# Meeting Notes

Subject:	Meeting Minutes – Community Advisory Group (CAG) Meeting #6		
Client:	Illinois Department of Transportation – Region 2 – District 2		
Project:	IDOT PTB167/ITEM 20 WO 3: IL 2 CSS	Project No:	226558
Meeting Date / Time:	February 5, 2015 / 5:30 p.m. – 7:30 p.m.	Meeting Location:	Byron Public Library, Byron, IL
Notes by:	HDR

IL 2 PROPOSED GEOMETRY  
ALTERNATIVE 1  
KENNEDY HILL TO MERIDIAN RD

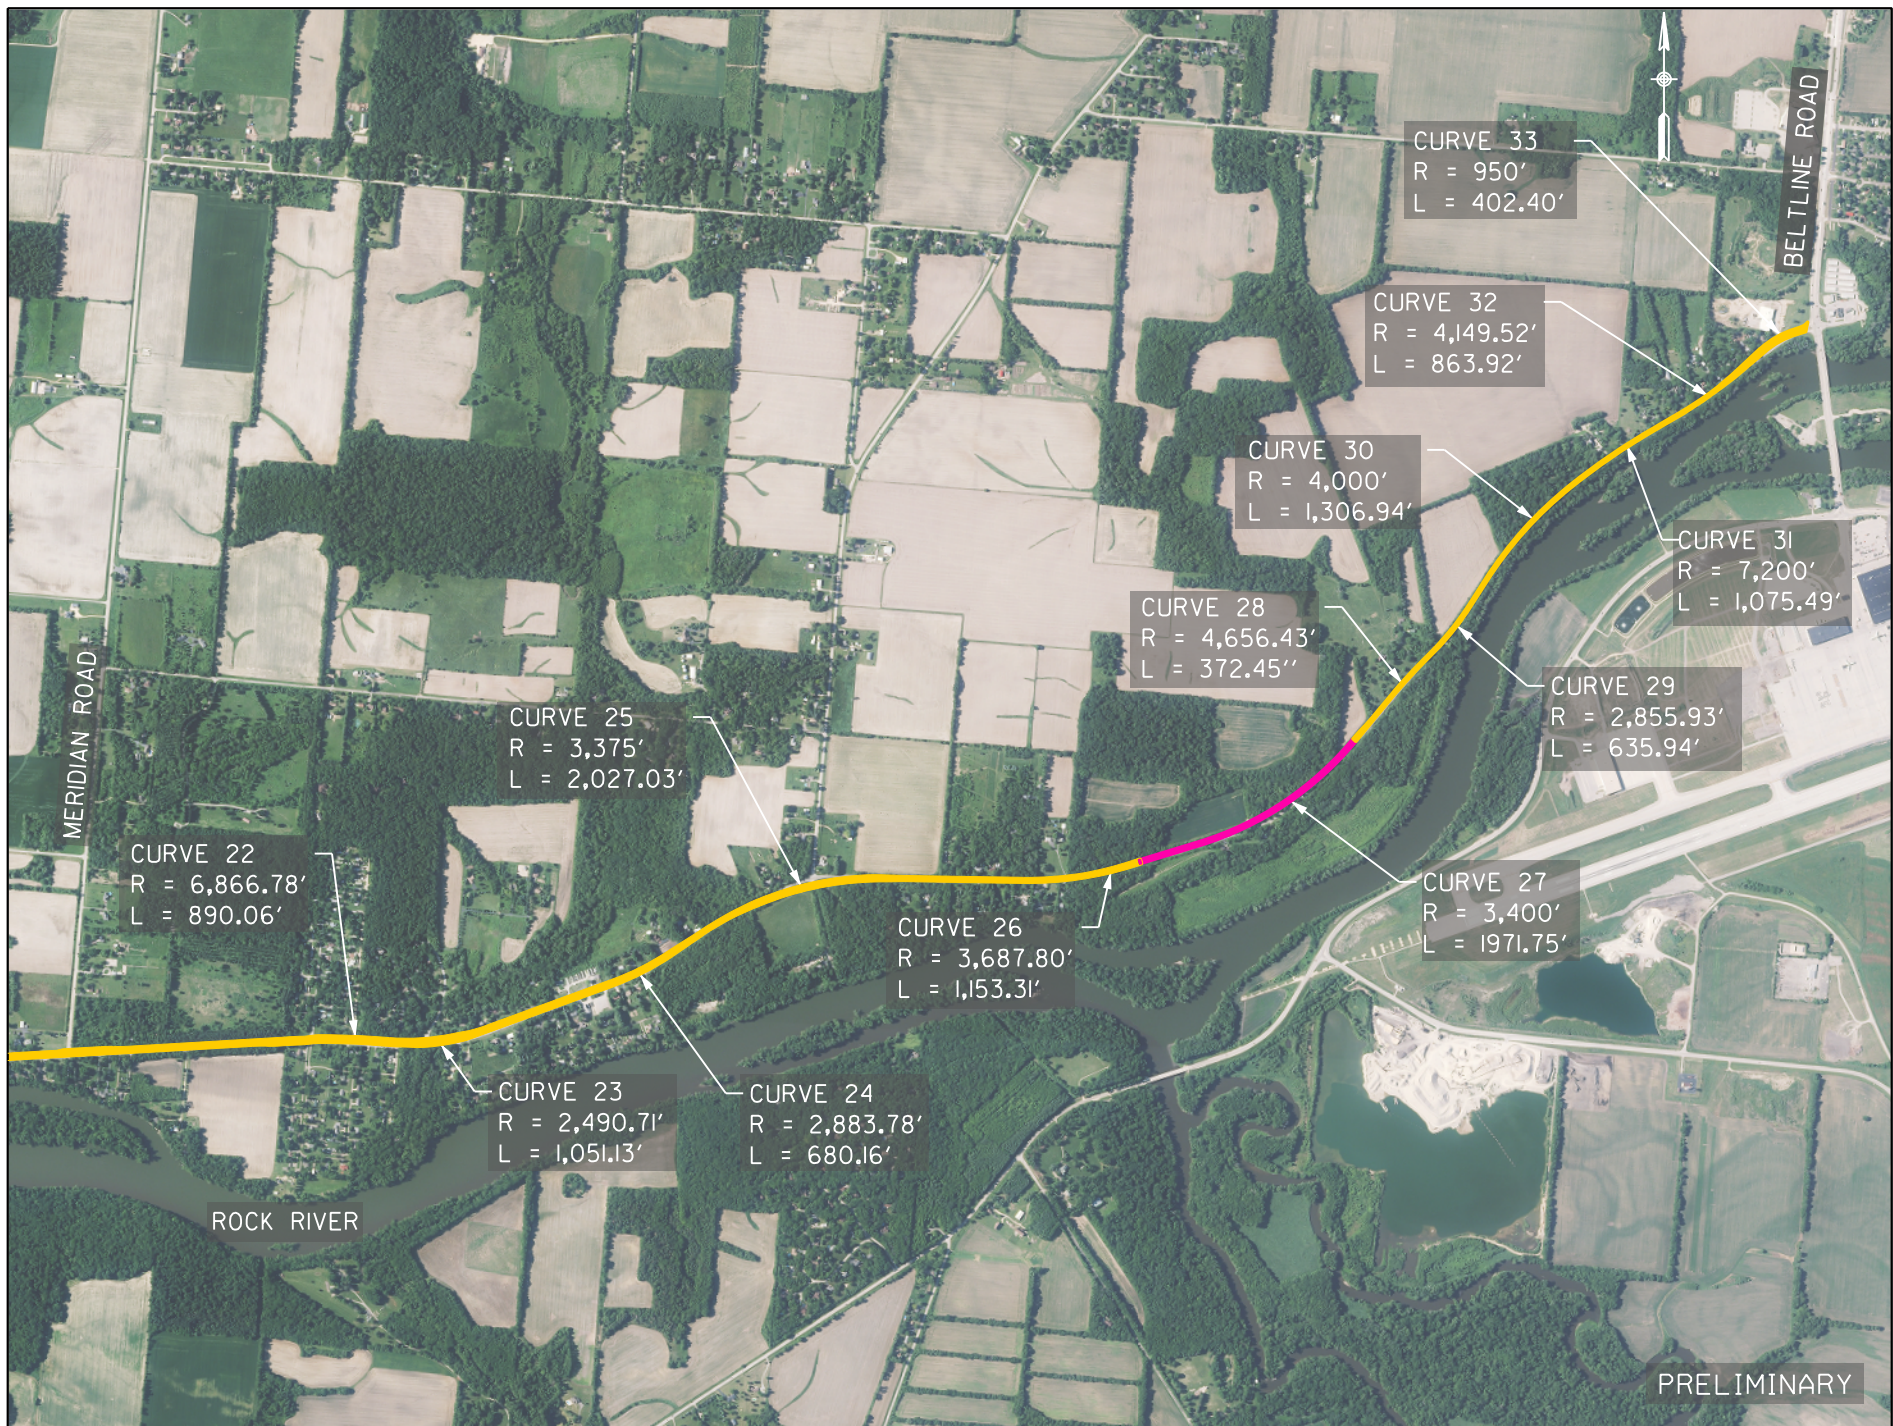
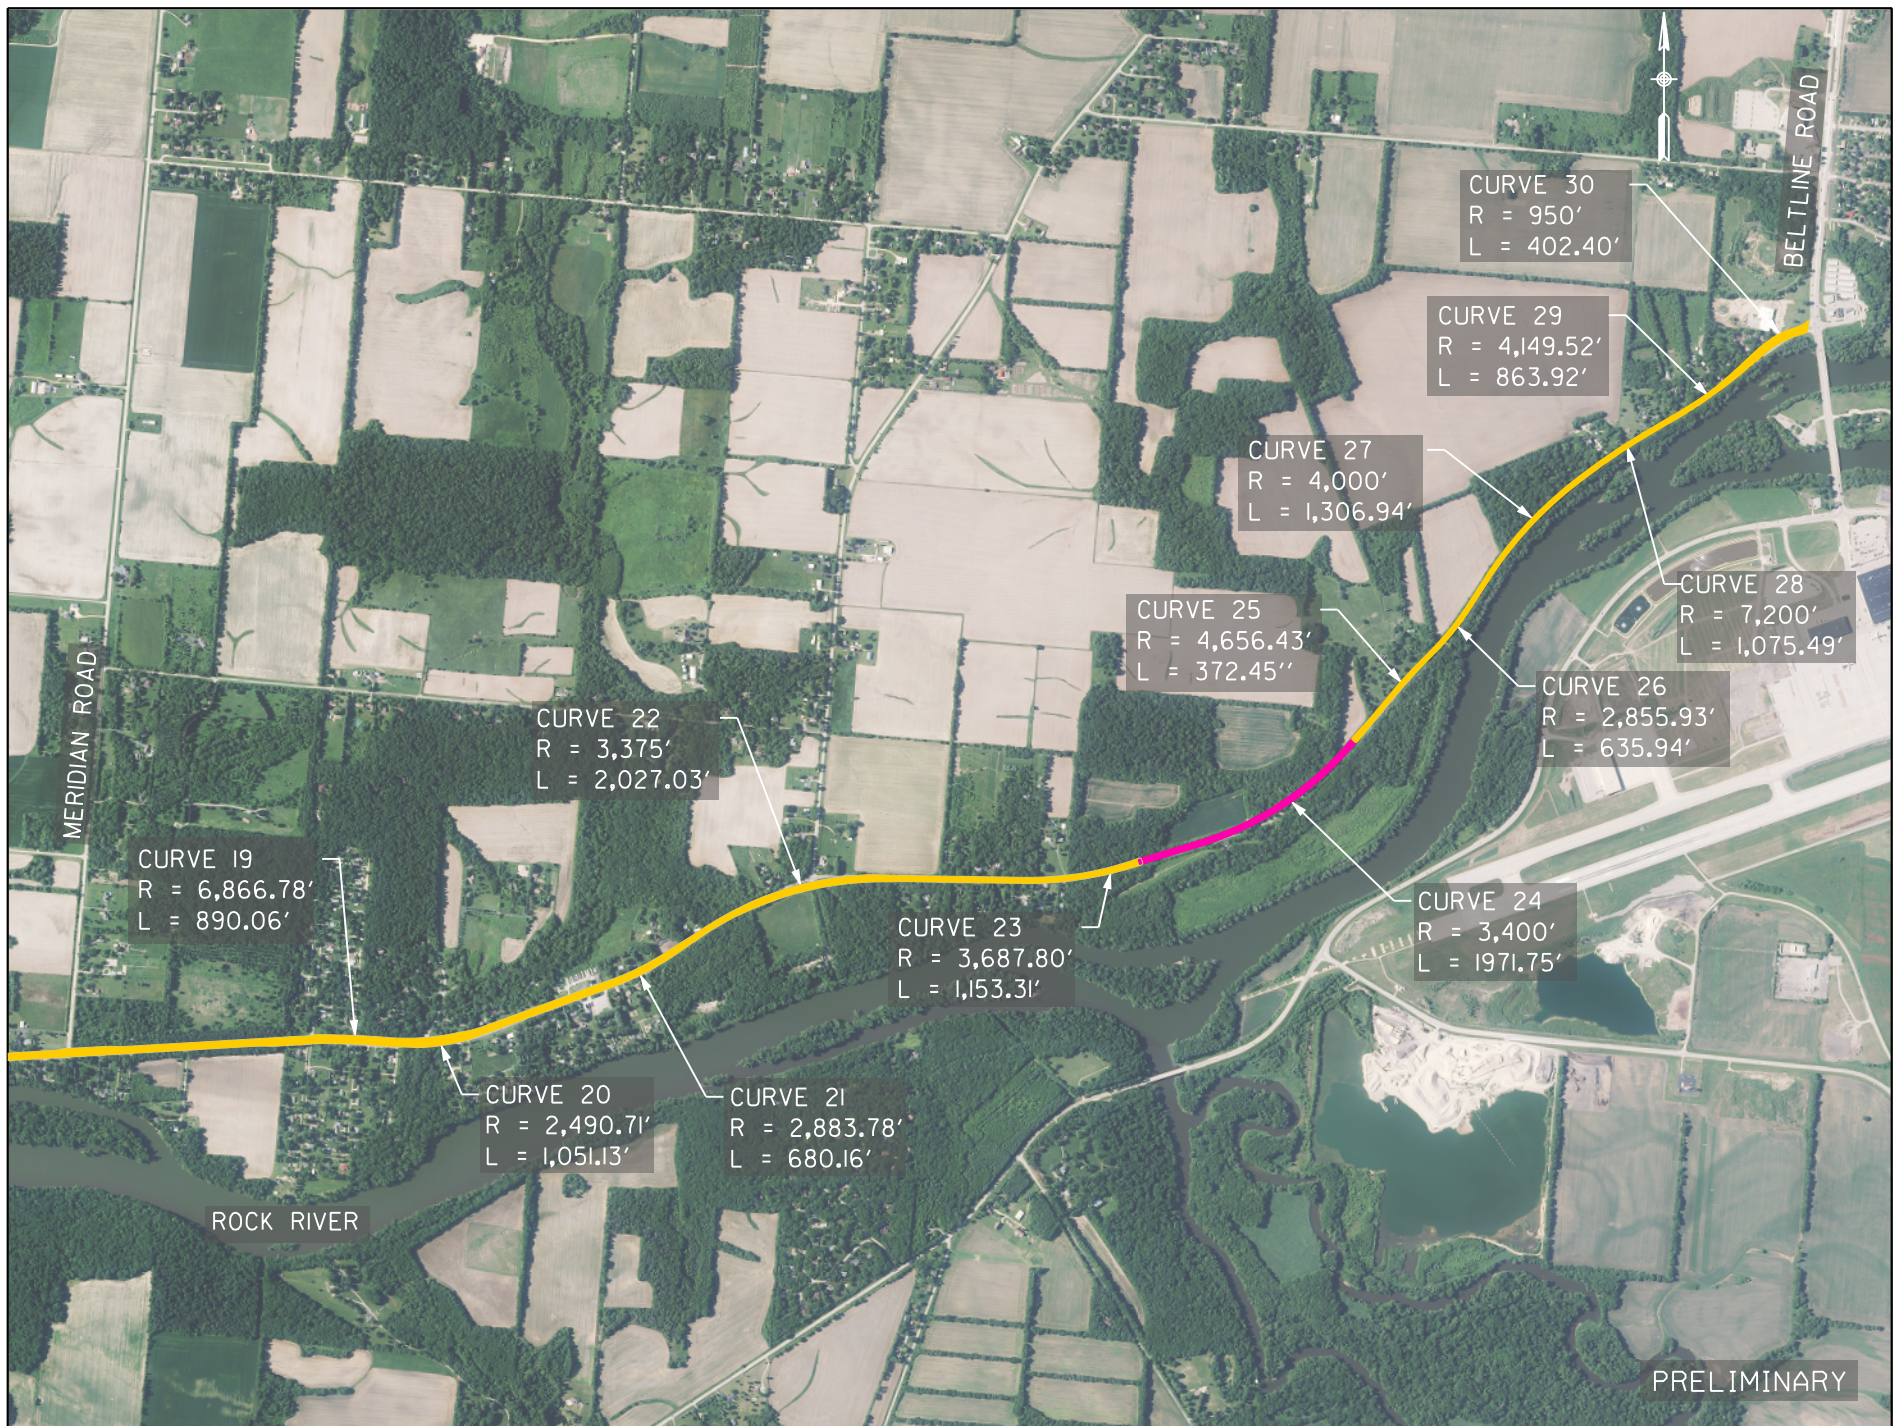
CAG Question: Why can't curb and gutter be used here to narrow the roadway and avoid the gate house?

CAG Question: Why can't the river be filled in?

CAG Comment: It is felt that the gate house is a part of the McCormick Estate and that some within the CAG would like it preserved.

CAG Comment: Alternative 2 is liked especially if the increased area between the river and the roadway could be used for recreational use, such as camping.

CAG Question: If recreational improvements of the rest area resulted in higher use, could a left turn lane be installed?

CAG Question: Could the alignment be moved back to existing sooner in order to minimize private property impacts?

Answer: Curb and gutter results in a reduction of the speed limit. This is not allowed based upon roadway classification and driver expectancy.

Answer: It may, it is a very difficult process compared to impacts to the guard house.

Response: IDOT stated that if turn lanes are warranted based on volume, turn lanes would be provided.

Response: IDOT indicated that they thought they could and would evaluate it.

IL 2 PROPOSED GEOMETRY  
ALTERNATIVE 1  
MERIDIAN RD TO BELTLINE RD

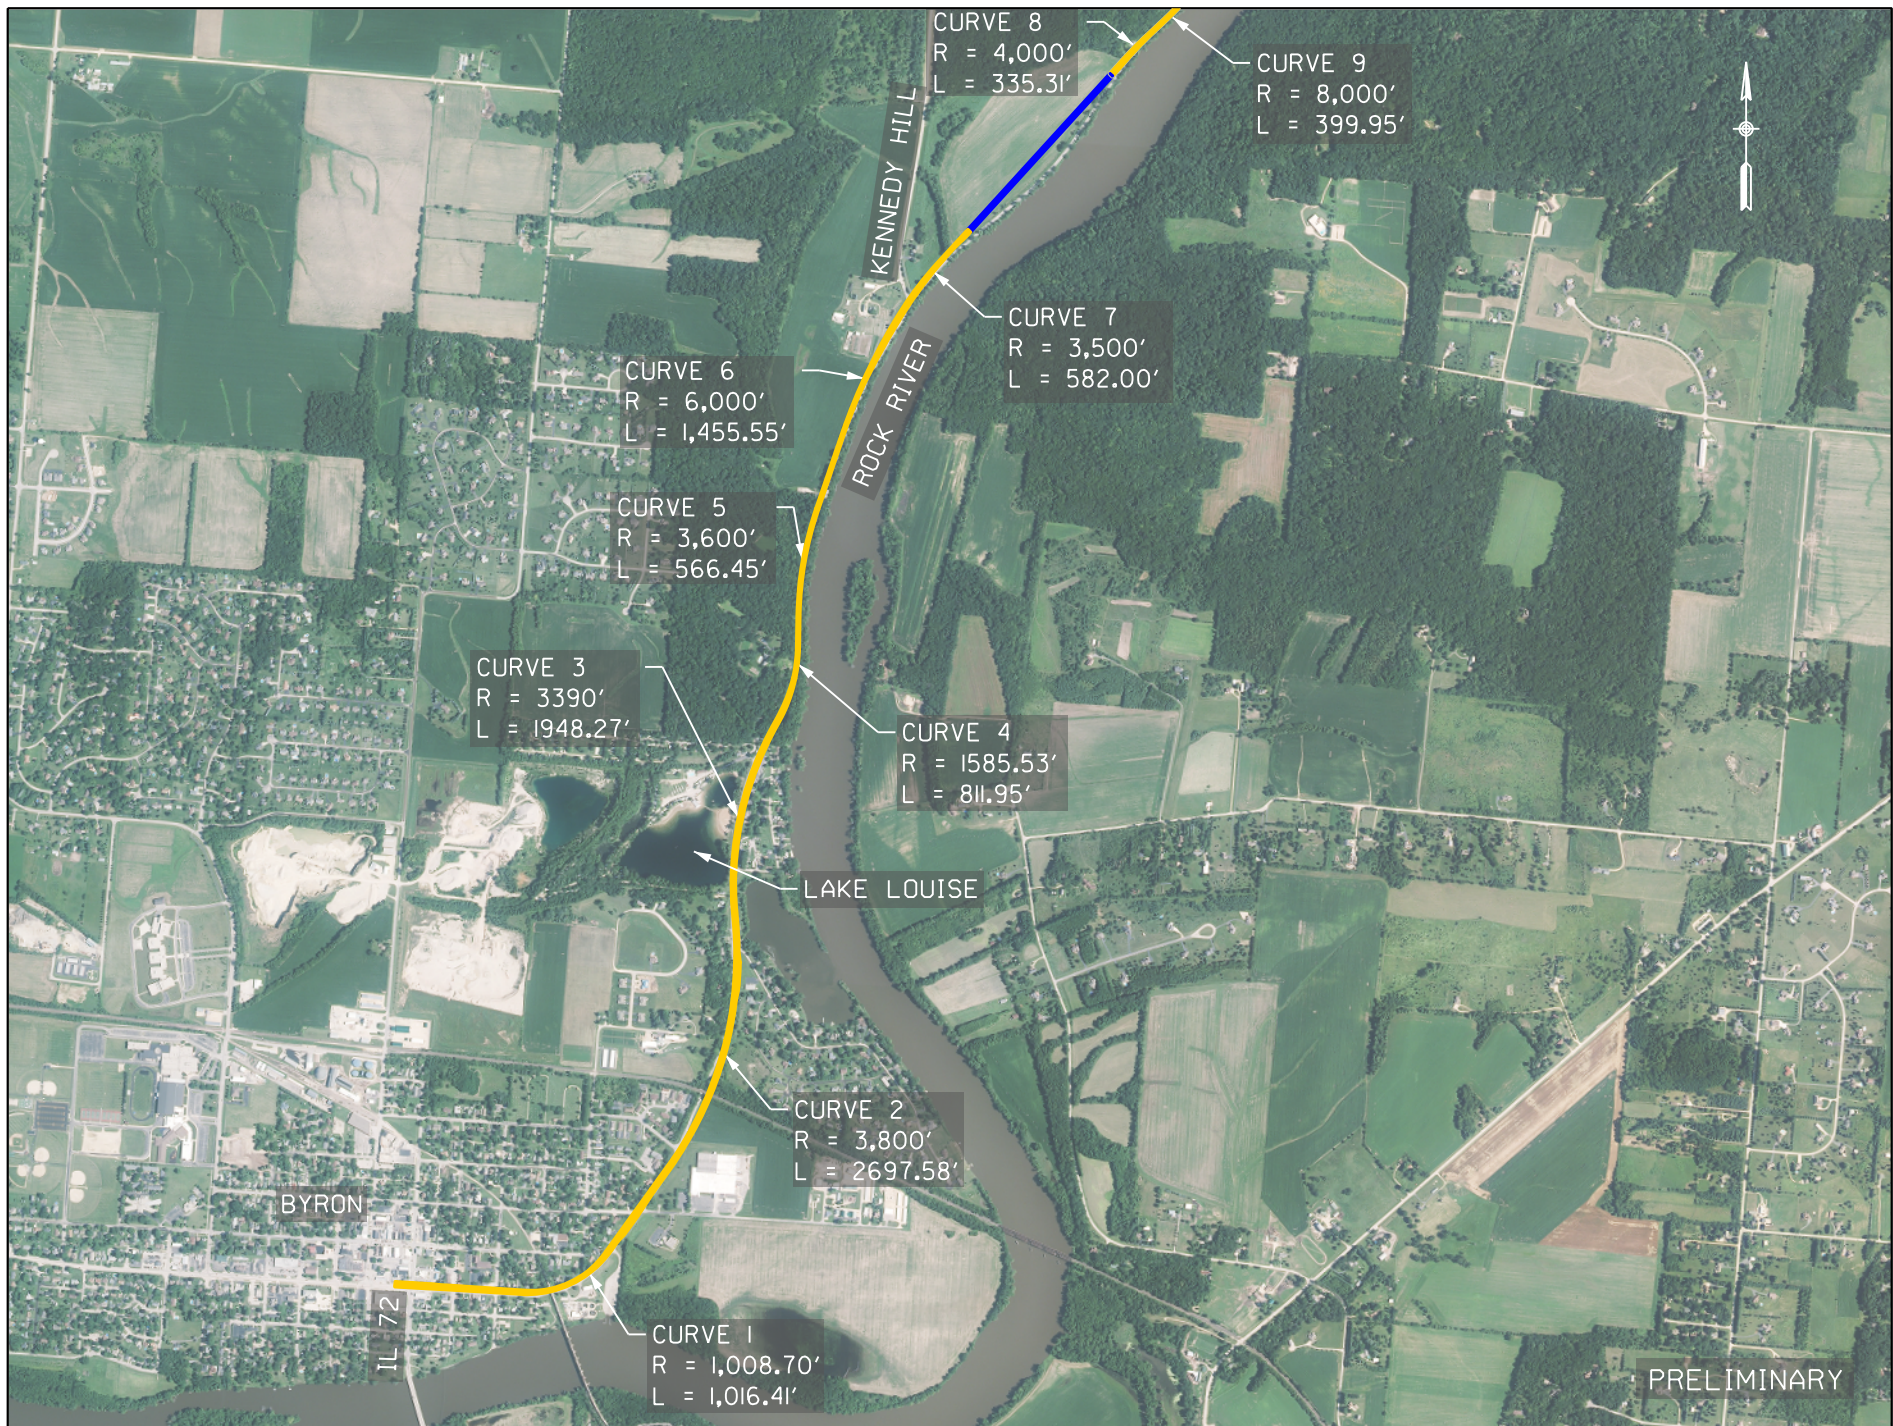
- ❖ South of Smith Farm a southbound passing lane is introduced along with the flattening of a curve.  
CAG Comment: An indian village is known to exist near curve 27.

CAG Question: Could a median break be given on Beltline Road?

Response: As part of the archeological survey limits will be provided.
- ❖ The alignment near John's Mounds will move closer to the river. The existing edge of pavement will be held constant and all improvements dimensioned from that point.

Response: No, a median break would not be allowed, either on Beltline Road or on IL 2.
